6803B **County Permit Review Worksheet** 1426

IMPROVEMENT PERMIT for a RESIDENTIAL ON-SITE WASTEWATER TREATMENT & DISPOSAL SYSTEM

GWS Septic System Design Review

SEPTIC SYSTEM DESIGN REVIEW WORKSHEET

Scale: 1 inch equals 50 feet	S&ME	Faison-Sample Road, LLC	FIGURE
Drawn by: JBP		Lot 65	
Reviewed by: Jeremy P. Michelone, RS		Mecklenburg County, NC	1
Date: March, 2007	ENVIRONMENTAL SERVICES · ENGINEERING · TESTING	S&ME Project #1588-05-091

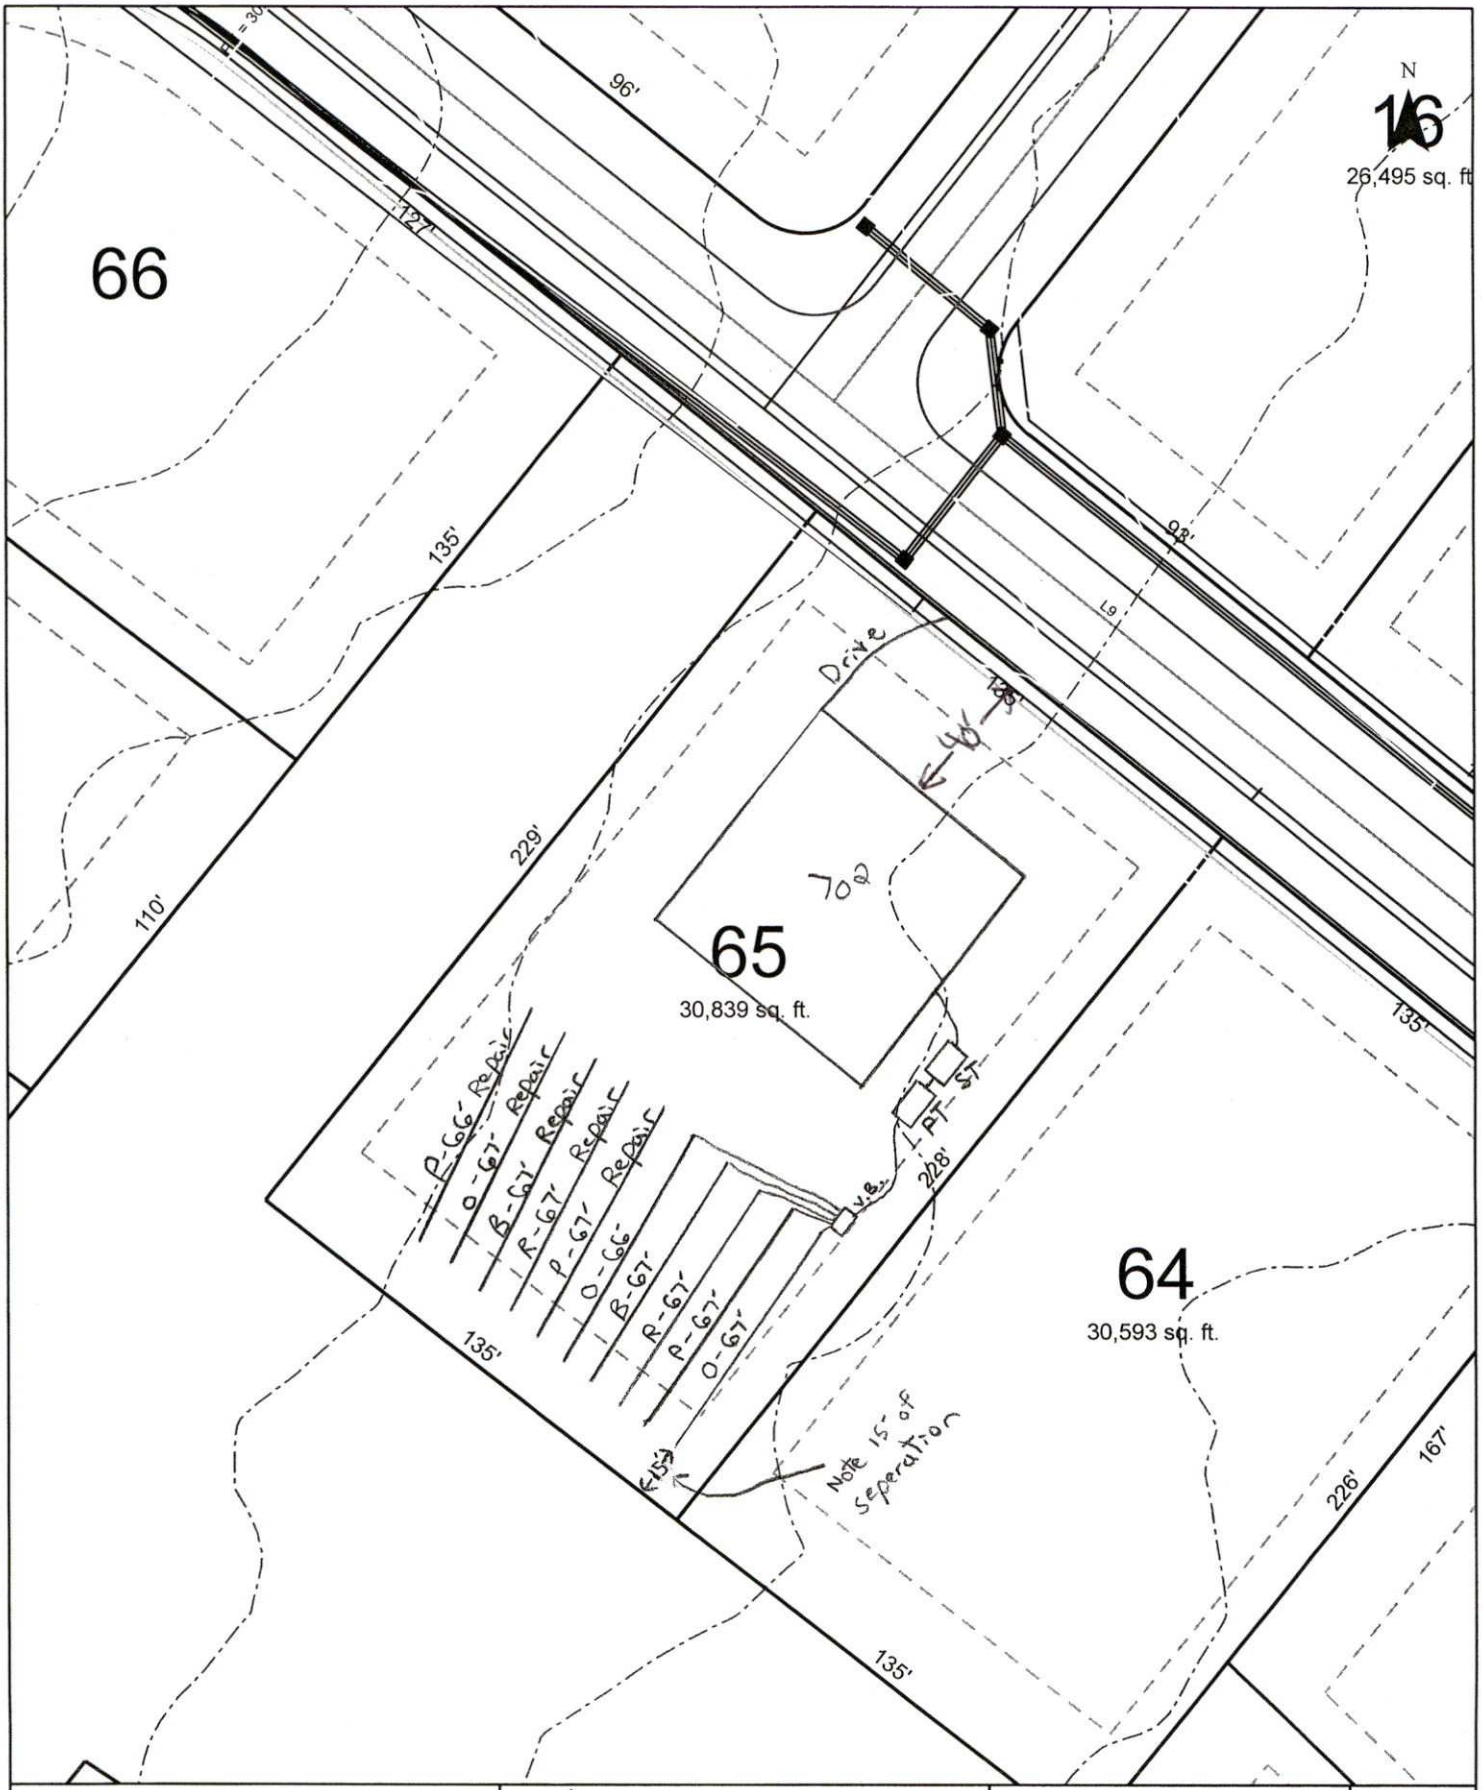
Please review the attached system sketch and design specifications for the Improvement Permit. Any additions or revisions you feel are necessary can be made on the Improvement Permit. Please call if you have questions or comments.

1. Install system using 3 ft. wide trenches.								
3. System design requires effluent pump for distribution.								
4. 100% Repair area is required.

Sketch of Soil Evaluation Locations

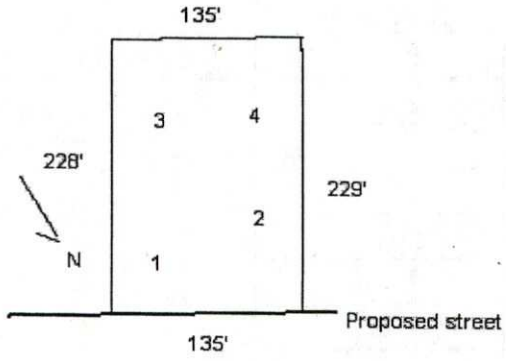
1. Need updated application on file for 5 bedrooms.
2. Update soil report to reflect 5 bedroom evaluation.
